SITE AUDIT REPORT FOR SAS 304

15-33 BRIGHTON AVENUE, CROYDON PARK, NSW

Prepared for Andree Shehadeh of Dyldam | 6 March 2020

Figure 5: Reproduced by the Auditor to show the street address of each area of the site (source: SIXMaps). This can be referred to when implementing the Auditor’s additional suggestions regarding the data gap investigation.

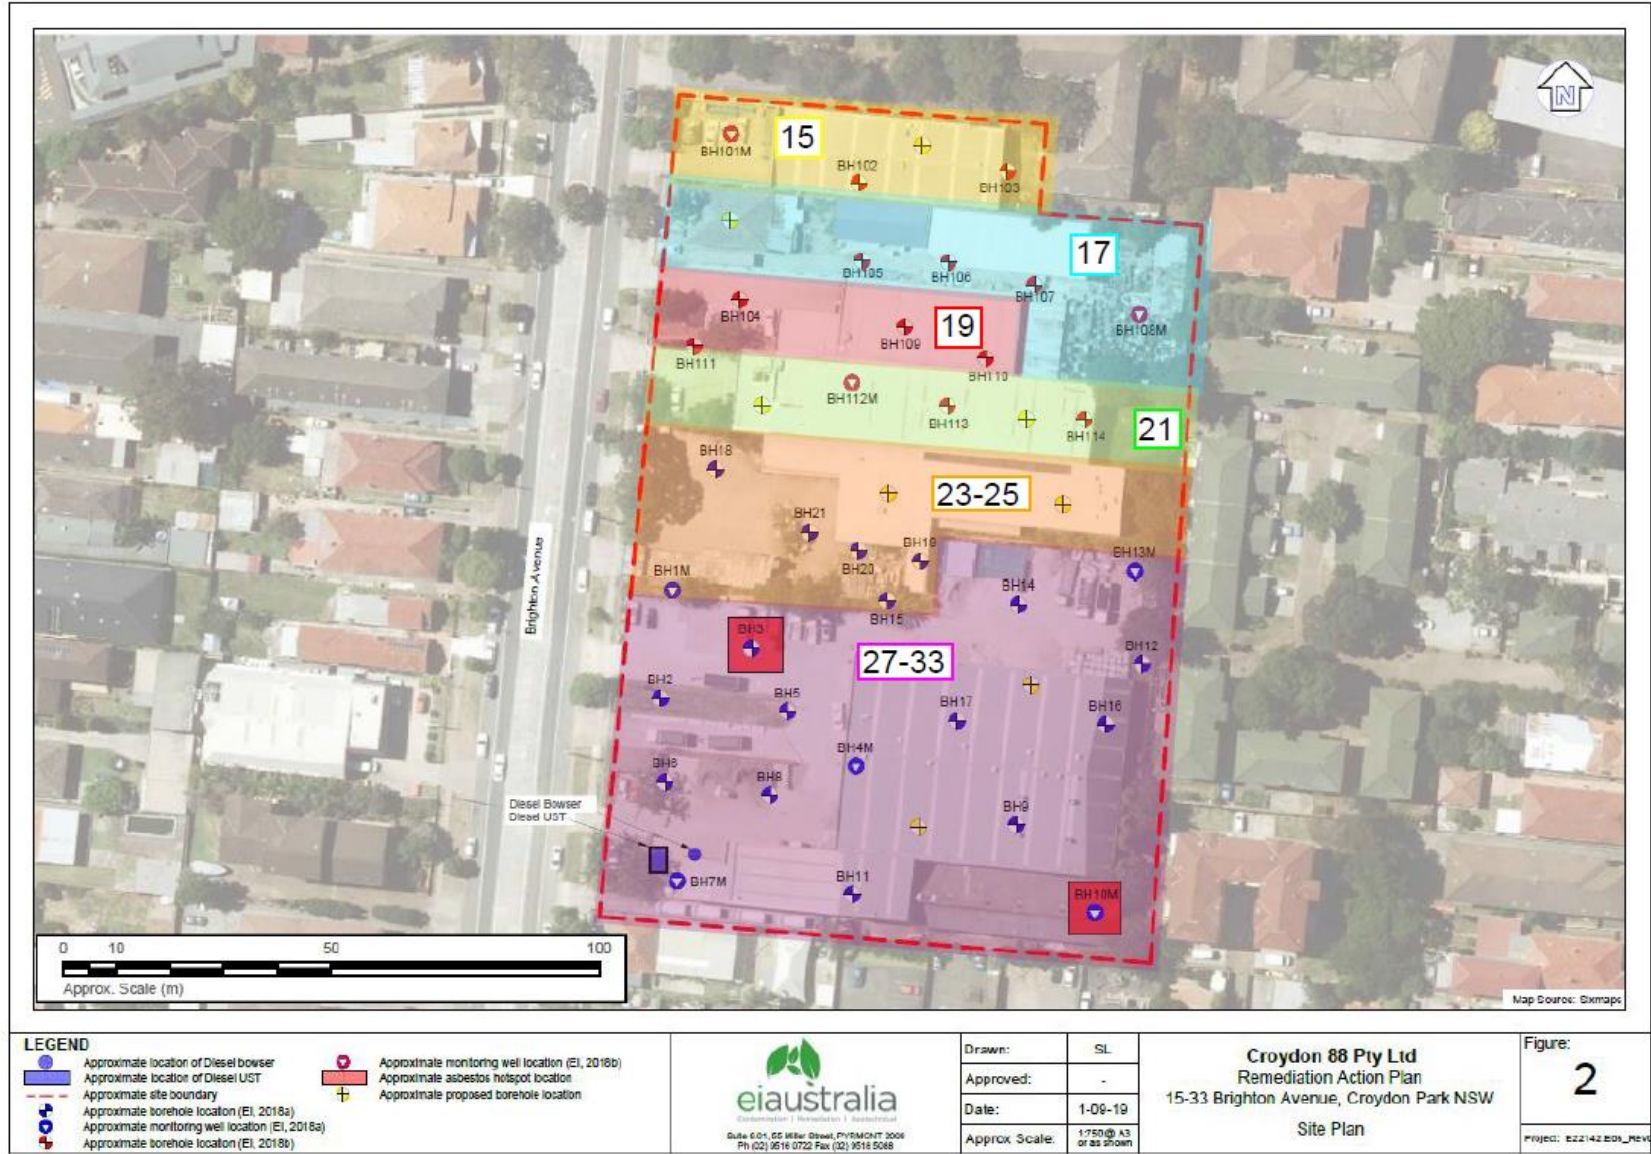
After review of the RAP, the Auditor notes that there has been insufficient delineation of previous site use, including: (Refer to Figure 5 in Appendix A).
